ADA Curb Ramp New Construction Inspection Form (Combination)

NW Curtis

NW Pacific

COMBINATION RAMP (C)

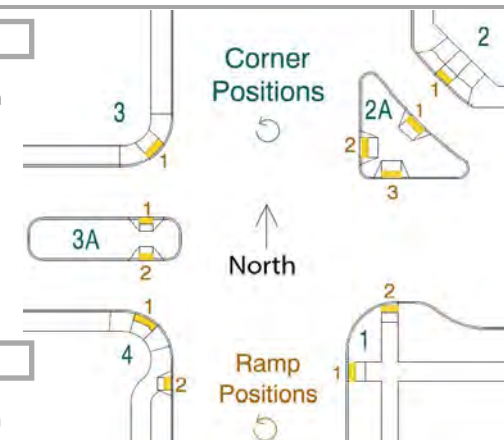
Ramp run 2, Ramp run 3, clear width less than 3ft
